Docket Item # 7  
BAR CASE # 2008-0099

BAR Meeting  
September 17, 2008

**ISSUE:** Alterations  
**APPLICANT:** Donna Epperson  
**LOCATION:** 211 North Alfred Street  
**ZONE:** RB/Residential

Figure 2. Existing third-story windows.

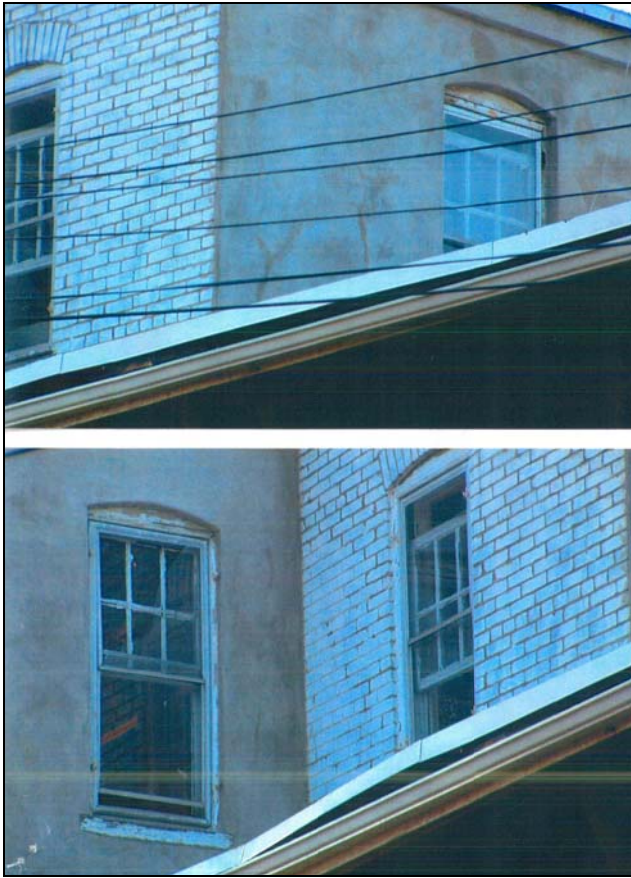
In respect to the request for replacement windows, Staff has met with the applicant on site and examined the windows. As stated previously, the one-over-one windows on the front (west) and two-over-two windows on the south and east elevations, appear to be original. The difference in lite pattern from the front to the side is typical and characteristic of buildings of this era. While many of the windows clearly show areas of deterioration, Staff feels that they can and should be retained and repaired, rather than whole-sale replaced. As discussed in the *Design Guidelines*, windows are character-defining features of property, and historic windows, especially original windows, should be retained to the greatest extent possible. The non-historic windows on the third floor may be replaced with an appropriate window as requested.

Figure 4. Proposed reconstruction of porch: south and east elevations.

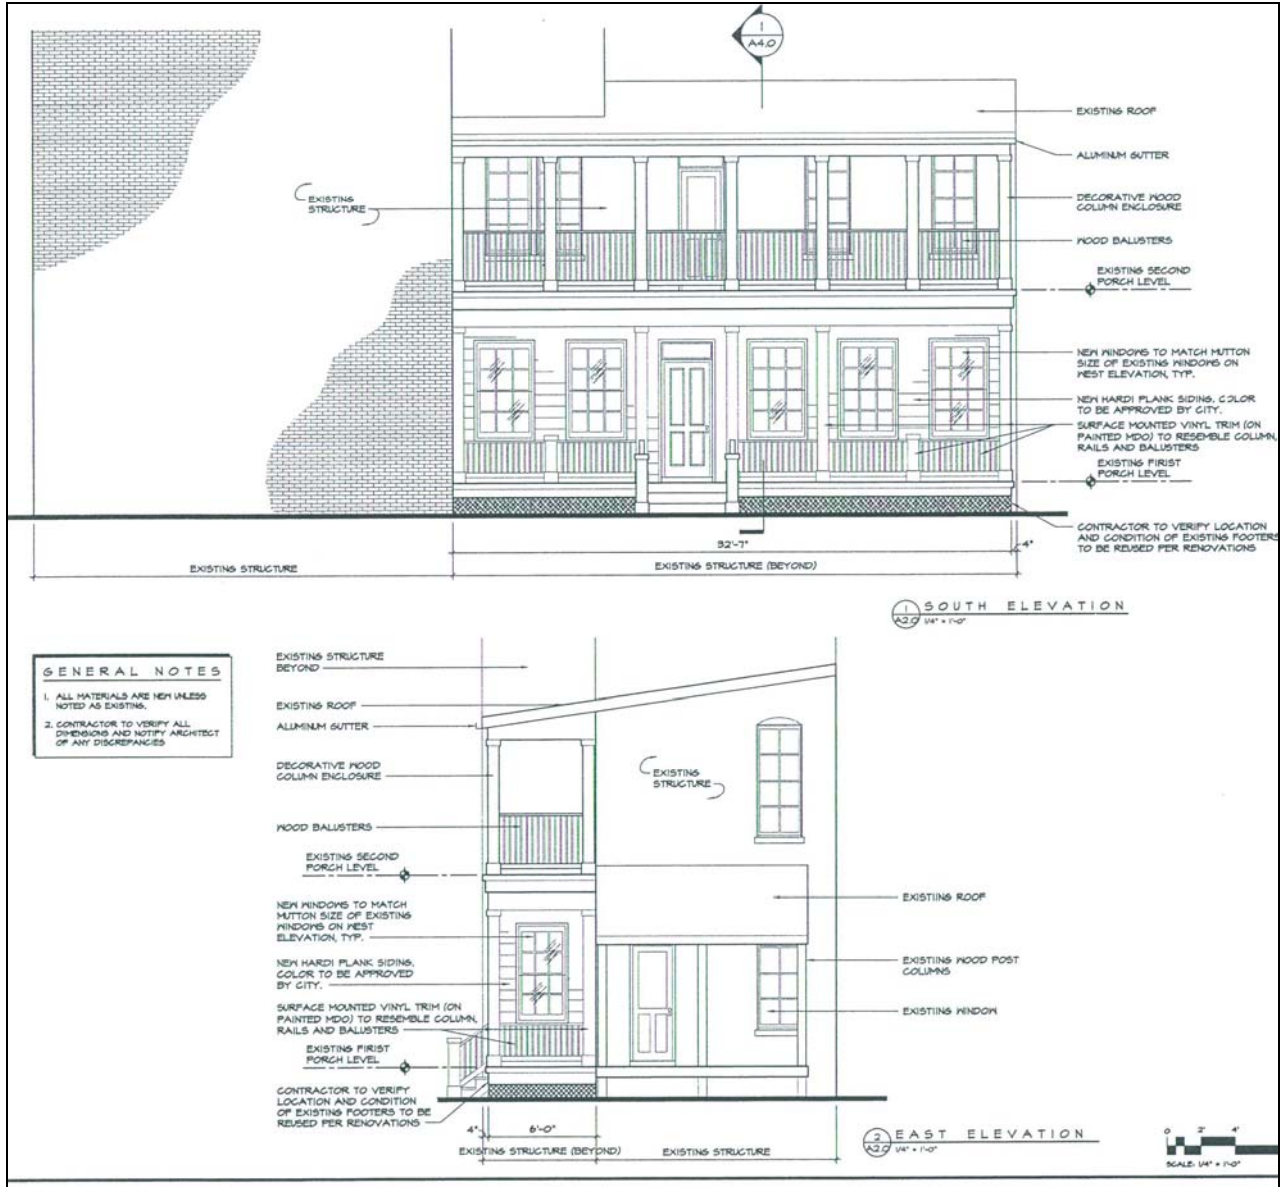
The current proposal for the porch includes maintaining the two-story height, with an enclosed first story. The existing roof will be maintained, and supported by eight new squared wood columns. A new aluminum gutter will be added. Squared wood pickets will form the handrail of the open second-story porch. The level of the second story will match the existing level. The first floor will be enclosed on both the east and south elevations. To mimic the second-story porch, the first floor will have four square support columns and a handrail. The applicant is showing the bottom handrail to have vinyl trim on painted MDO. Six double-hung, double-glazed, wood windows, with simulated divided lights will partially enclose the first level. The applicant is proposing to use a smooth-finish HardiPlank to complete the closure of the first level. New lattice will be located at the foundation of the reconstructed porch.

In general, Staff is supportive of the proposed changes to the property and the applicant's desire to reconstruct the porch in a more appropriate and compatible design. The applicant and their contractors have met with Staff to discuss the project numerous times prior to the filing of the application. In regards to the porch, Staff feels the design of the porch is appropriate and sympathetic to the historic building, evoking the typical evolution of side porches, with enclosures. The applicant desires to have the first level of the two-story porch enclosed as a sun room type space. Again, the new design is more appropriate than the existing design, which had utilized stucco and bare aluminum storm windows. However, as discussed with the applicant, Staff is concerned about the use of Hardiplank and any vinyl as materials on the porch. In Staff's opinion, since this is a reconstruction of a historic feature, the materiality should be as authentic as possible. Therefore, Staff would recommend that only wood siding be used for the first floor enclosure and that wood should be used for the handrails and columns. Also, Staff would recommend that the new windows on the first floor enclosure be one-over-one, double-hung windows, to allow for more openness and for the porch to read as a sunroom.

1. That the historic windows be retained and repaired, rather than replaced;
2. That only wood materials be used on the reconstructed porch, instead of Hardiplank or vinyl;
3. That Staff approve the selected color or stain for the new porch, including columns, railings, and enclosure; and
4. That the windows on the reconstructed porch be one-over-one, double-hung wood windows.

Figure 6. Specifications for proposed window replacement, sheet 1.

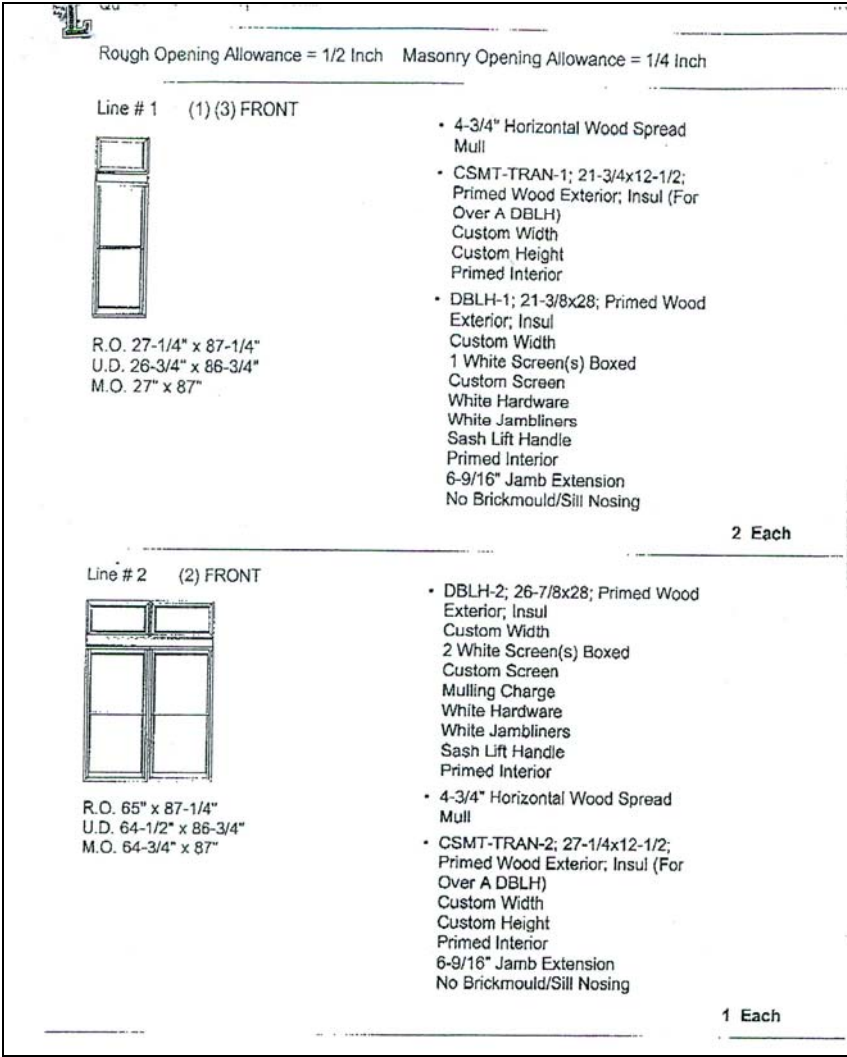
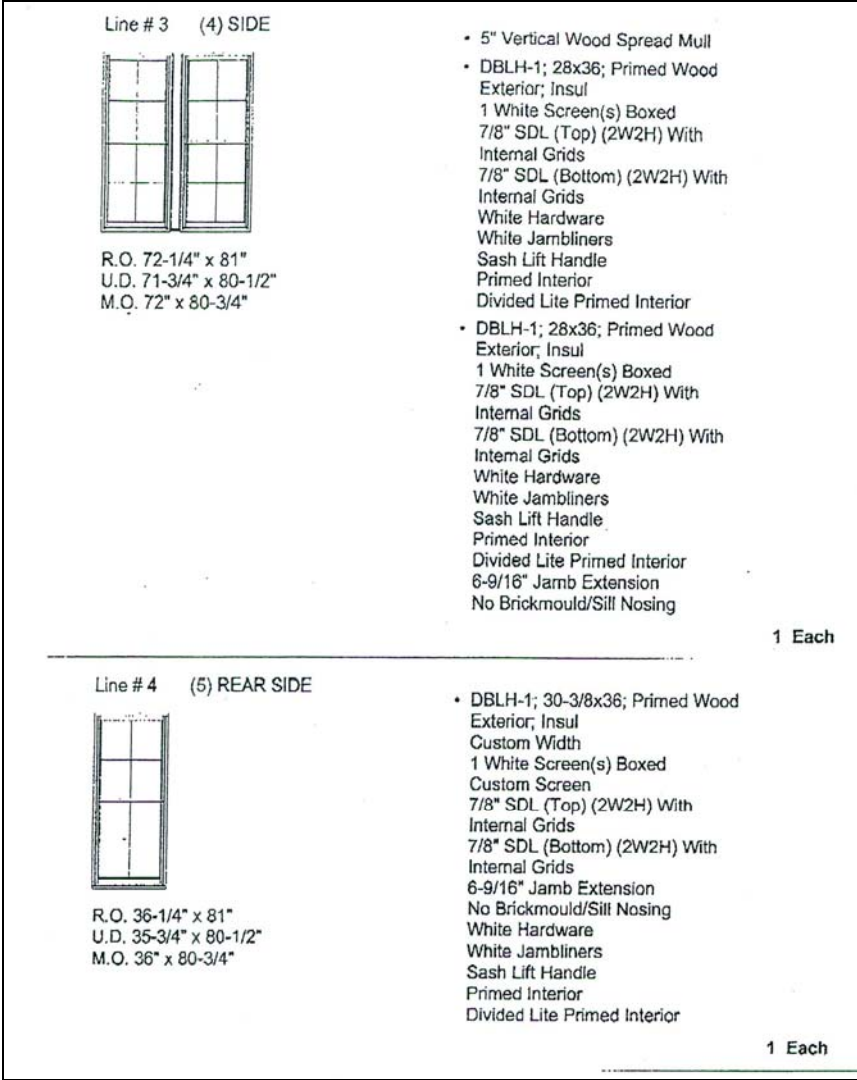
The applicant also proposes to replace all the existing wood windows, with new wood, double-hung windows consistent with the lite pattern and profile of the existing window. The proposed replacement windows will also be double-glazed, and for the units with a muntin, the muntin will be a simulated divided lite.
